CALIFORNIA COASTAL COMMISSION

**STAFF REPORT: PERMIT AMENDMENT**

APPLICATION NO.: A-5-RPV-93-005-A14
APPLICANT: Ocean Trails LP
AGENT: Kenneth A. Zuckerman, CEO

SUMMARY OF AMENDMENT 14:

FIGURE 4.1
LANDSLIDE "C"
 LANDSLIDE C

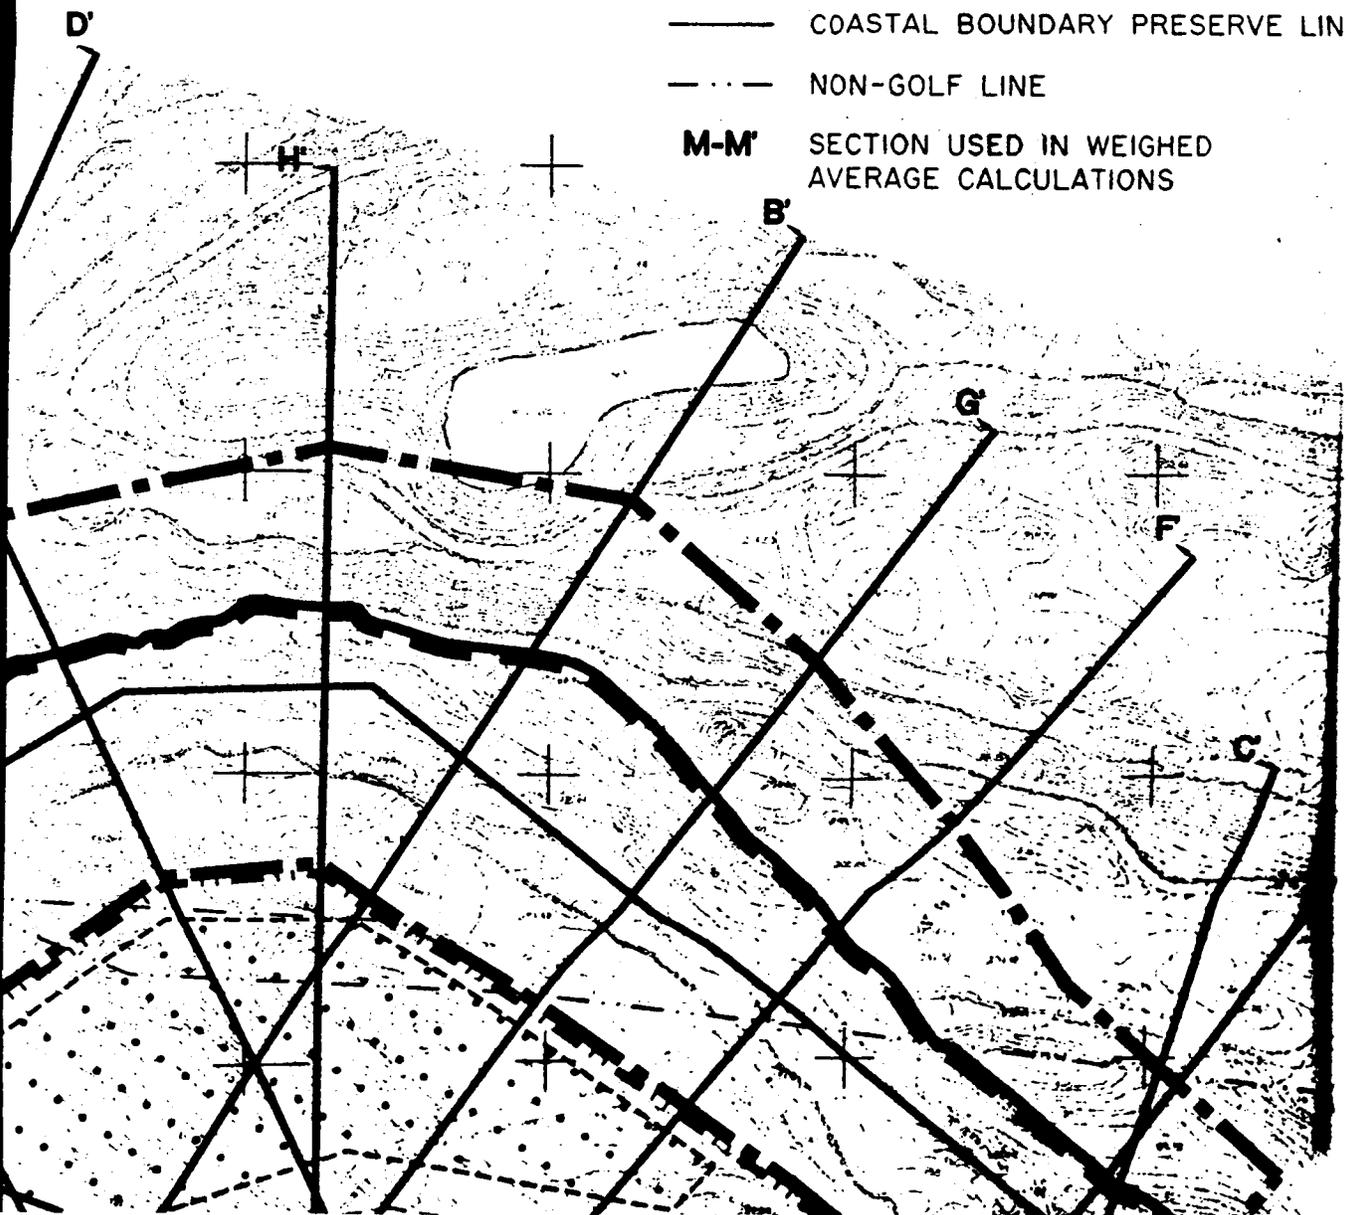
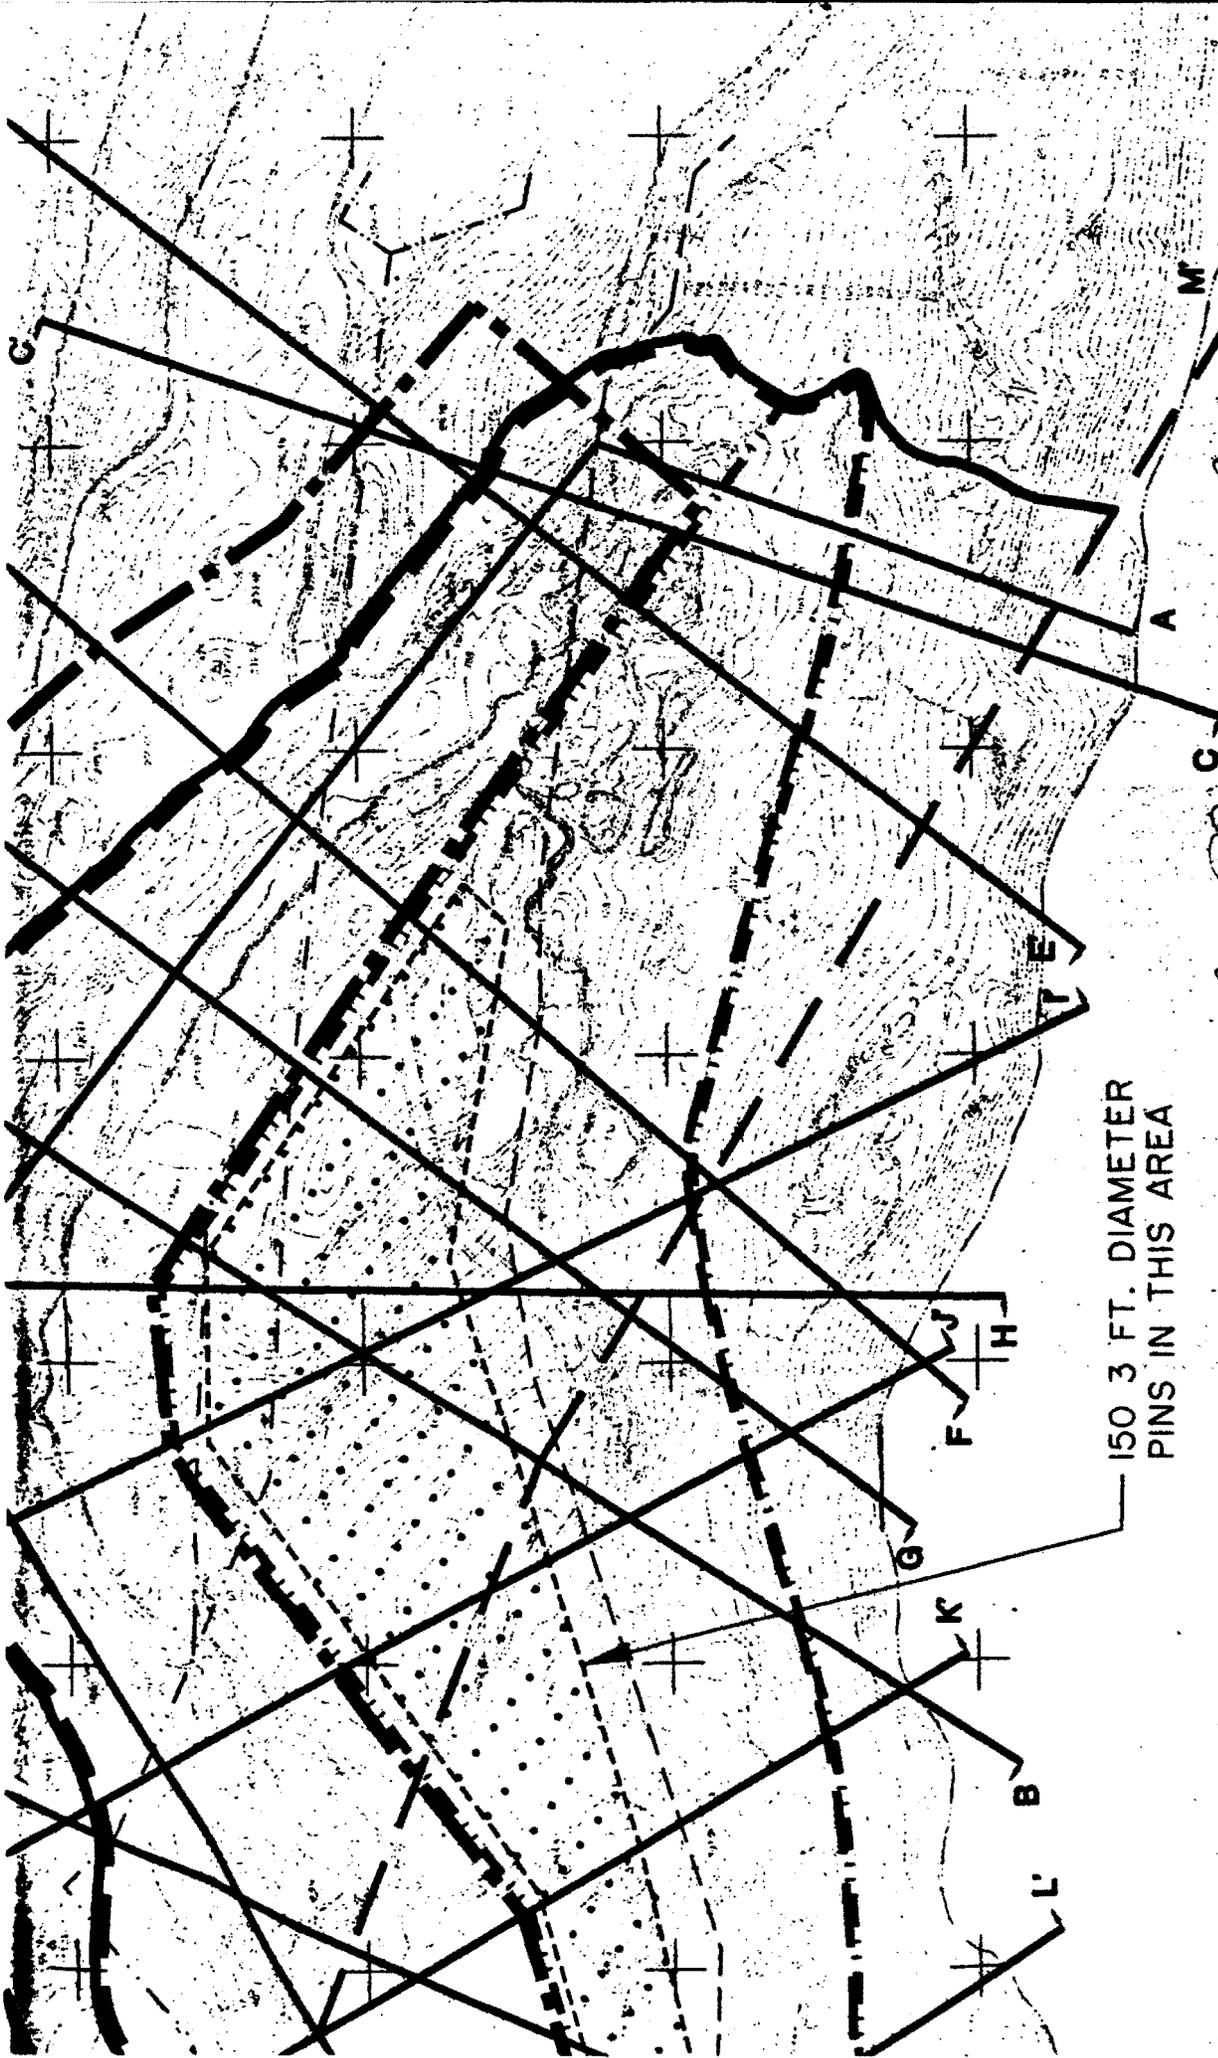
Proposed Shear Pin Design- The proposed shear pin design includes 20 rows of shear pins spaced at 20-foot centers. Rows are located approximately 30 feet apart. The report states that a total of 150 shear pins are proposed. However, a total of 164 shear pins are shown on the plan, Figure 4.1. Shear pins are to be 36-inch drilled cast-in-place piers with reinforcement consisting of a 30-inch diameter, 2-inch to 2 1/4-inch thick, 50 ksi steel pipe. The shear pins will be approximately 21 feet in length and extend roughly 10 feet above the basal rupture surface (or Upper Bentonite layer) of the landslide.

Geologic and Topographic Constraints- The shear pin plan (Figure 4.1 of the September 15, 1999 CC report), indicates that the "footprint" of the shear pin array will not be confined to the active landslide translational block (Abs), but will extend downslope approximately 300 feet to the west into the area that has been mapped as Active Rock Slump (Ars). In addition, the proposed shear pin array will traverse steep topographic slopes in the western one-third of the footprint. The placement of shear pins in steep terrain will likely require extensive grading for drilling equipment.

3. As shown in Figure 4.1 of the shear pin plan, the shear pin array footprint can provide more shear pin locations than the actual number required. We can avoid locations that need extensive grading and still have sufficient locations to install the required number of shear pins.

SECTION 2
SCALE: 1"=40'

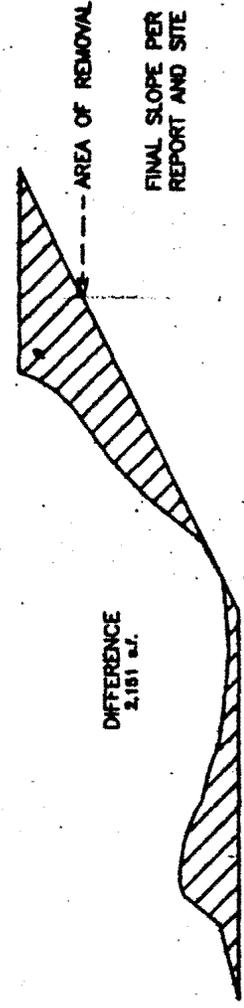
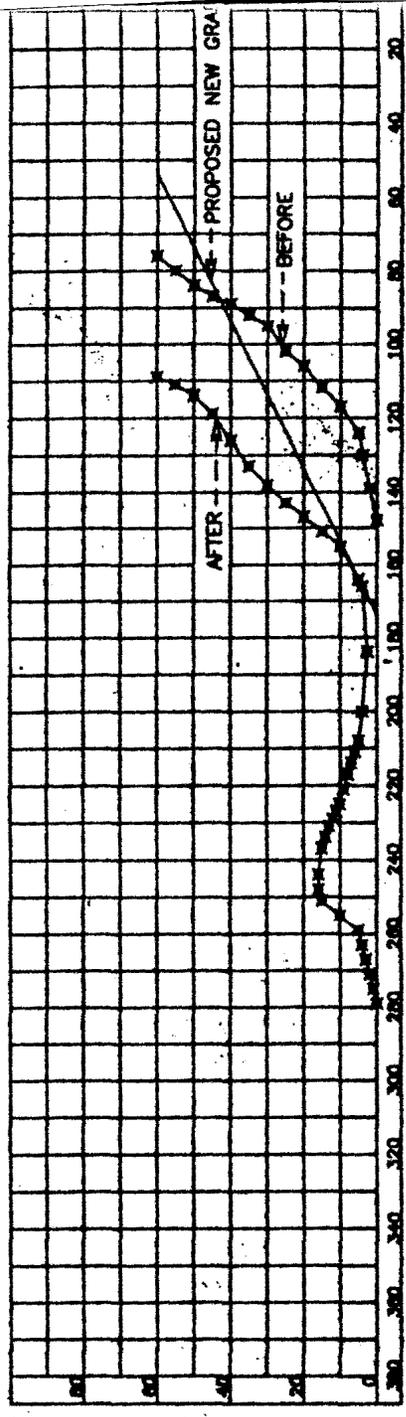
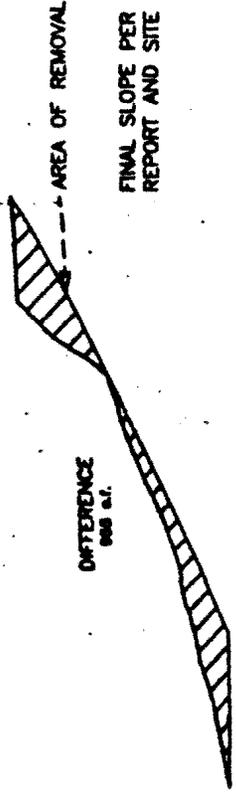
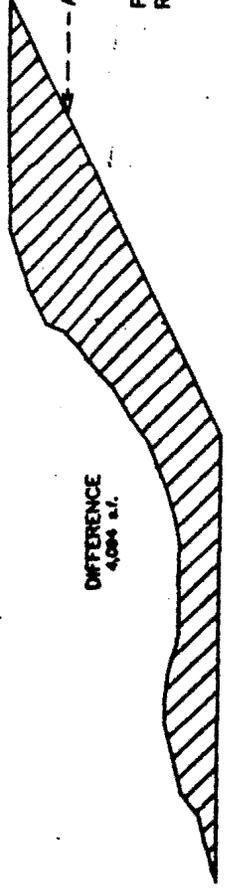
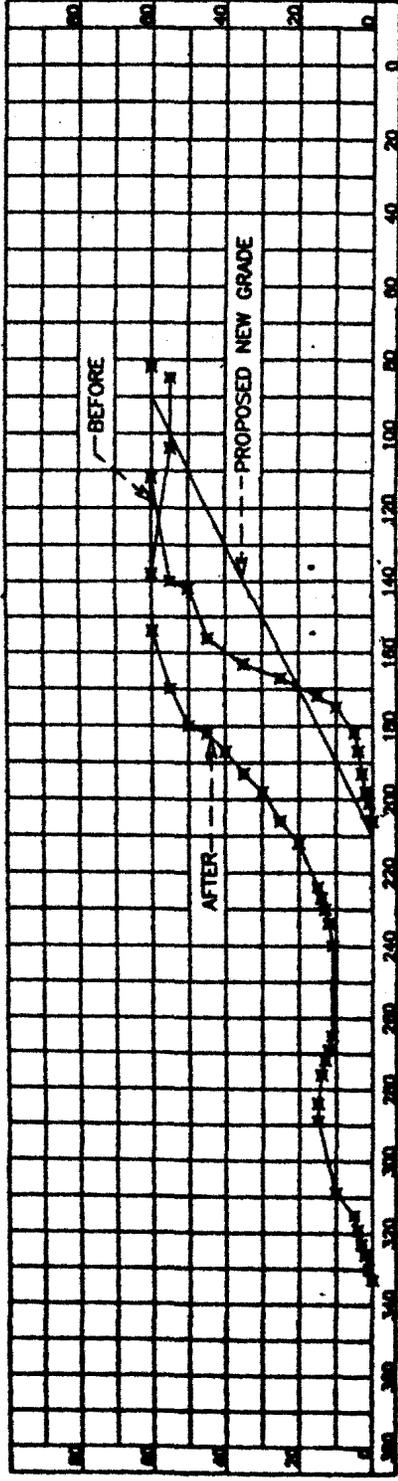
Geologic review of the surf repair plan. The provided plan is very preliminary. The proposed slope cut stops at the 60' contour; however, (1) the final cut may have to go further up the slope face to meet the natural slope; (2) no benching or terracing has been provided for the cut slope; (3) the preliminary design was proposed with only limited, general geotechnical information about the bluff face; (4) there has been no analysis of wave dynamics to determine whether this repair will be effective. This repair has not been reviewed by the City geologists. Because of this involvement with the toe of the slide, its review would require an analysis of the stability of the entire slide, and the relationship of

No stability analysis. The surf repair plan states that it is dependent on a bluff stability analyses done by others that has not yet been completed. Without such an analysis, the project cannot be evaluated. It assumes that the face of the bluff and the toe are not supporting the rest of the slide, but offers no evidence in support of this idea.

Lack of surf modeling. The proposal includes no modeling concerning what changes the work would accomplish with the surf. The entire plan is landward of the present water line. The focus of the surf repair plan is to reduce the reflected wave energy by relocating the toe of the bluff to its pre-slide landward position. It includes a very general indication of what the bottom configuration will be after the toe is excavated out. As noted above there is no information concerning historic configuration of the seafloor in this location. There
